Lowden Manor House, Chippenham

Heritage Statement Addendum

Submission Document – Listed Building Application

July 2026

7 Bedroom Sections

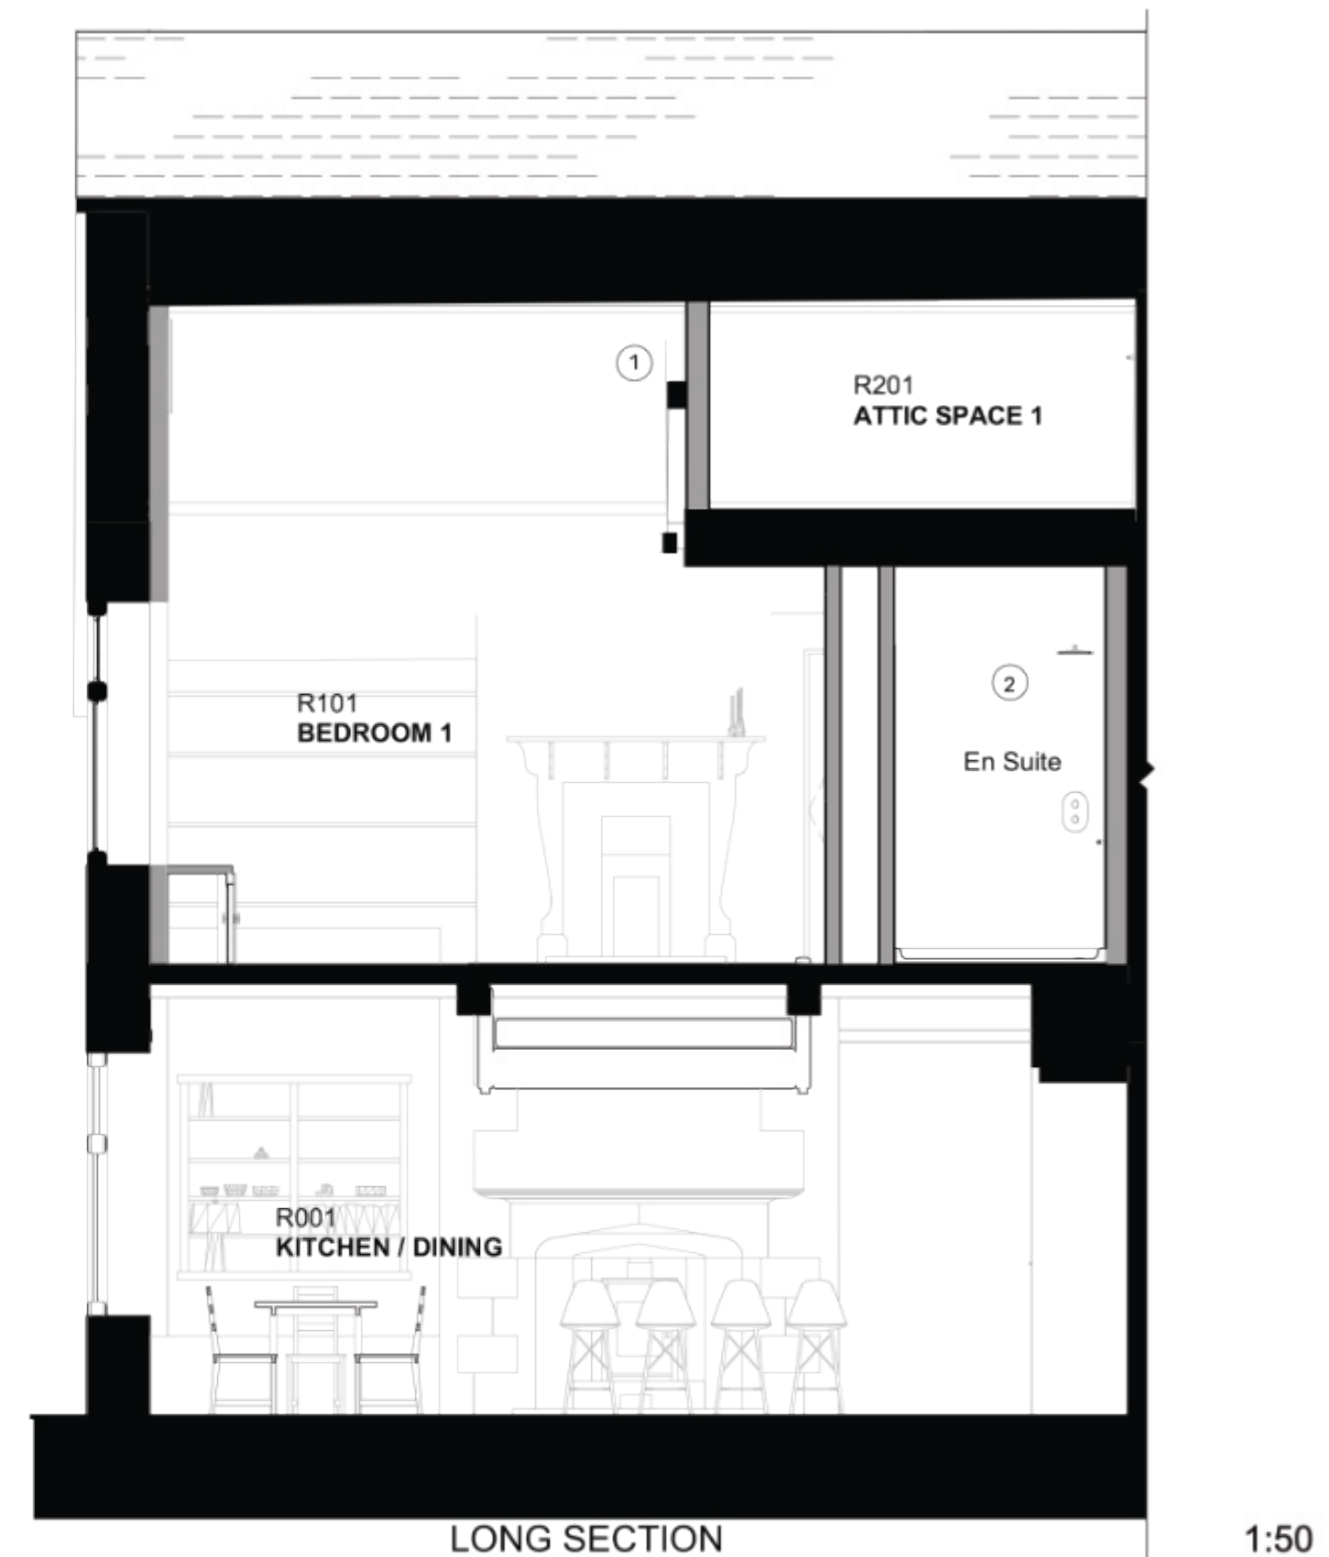
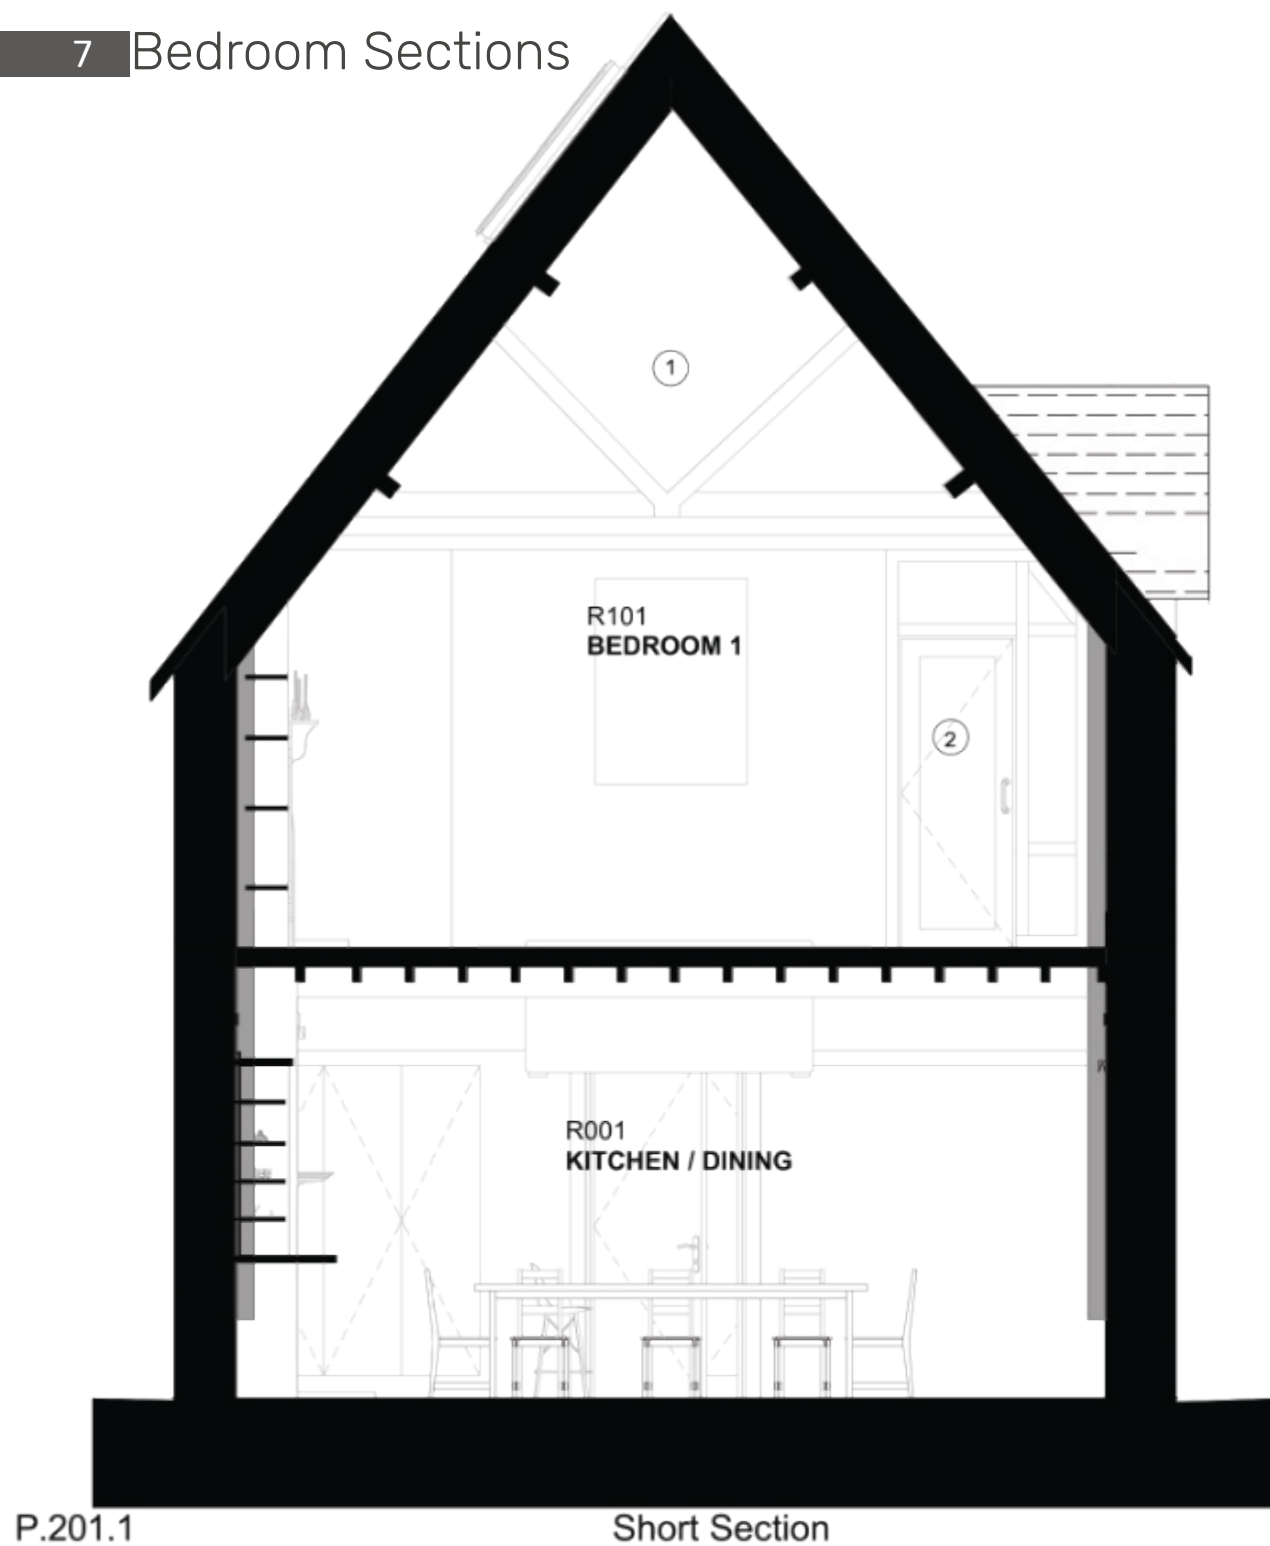
- ① **Creation of vaulted ceiling:**
- Existing flat ceiling to south of truss removed.
 - Existing truss restored and exposed within the space.
 - New partition wall installed to separate vaulted ceiling zone in R101 with attic zone R201.

- ② **Creation of en-suite bathroom:**
- New en-suite bathroom in corner of existing limits of R101.
 - Bathroom drainage to join to existing pipes externally.
 - Timber framed, frosted glass partition and outward swing door into en-suite

8 Door Elevation as Proposed

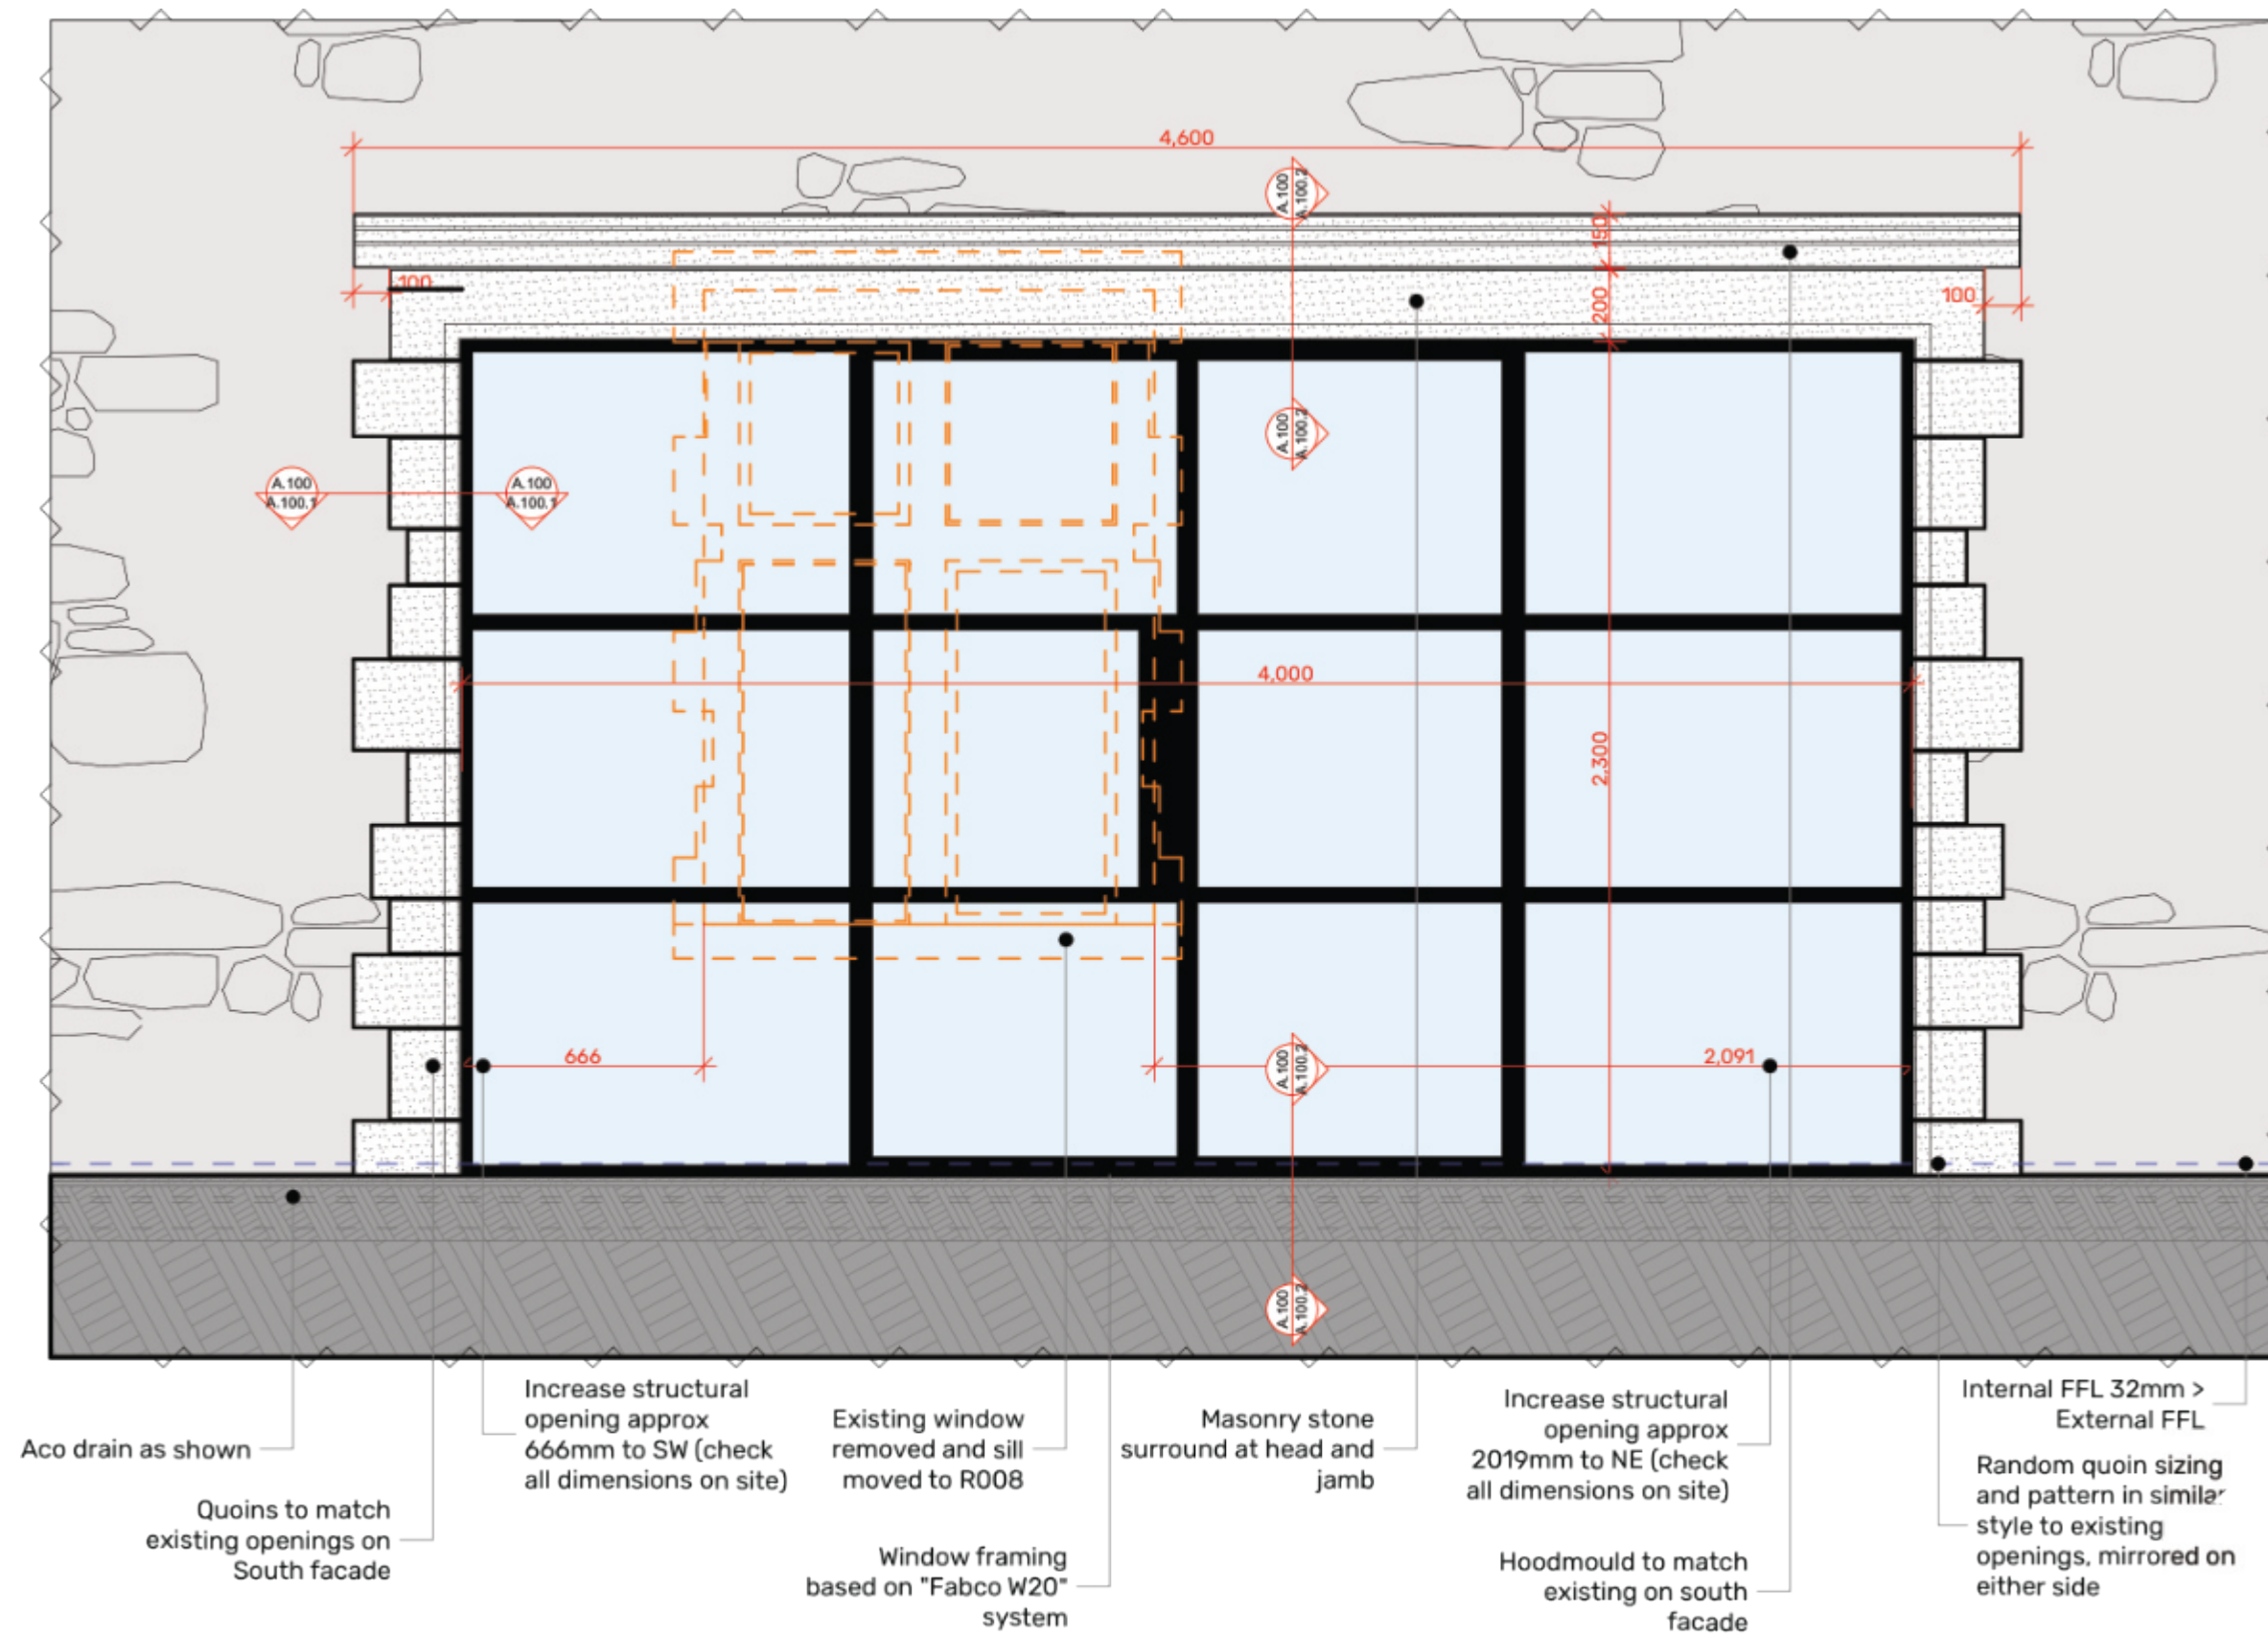
- Install casement doors in East wall of Kitchen / Dining. Previous permission allowed for the installation of sliding doors with aluminium surrounds. The new proposal substitutes the sliding doors for steel casement doors and looks to reuse existing stone quoins and hood moulds for the new surround.

Natural fabco steel door system
installed to adjusted structural
opening
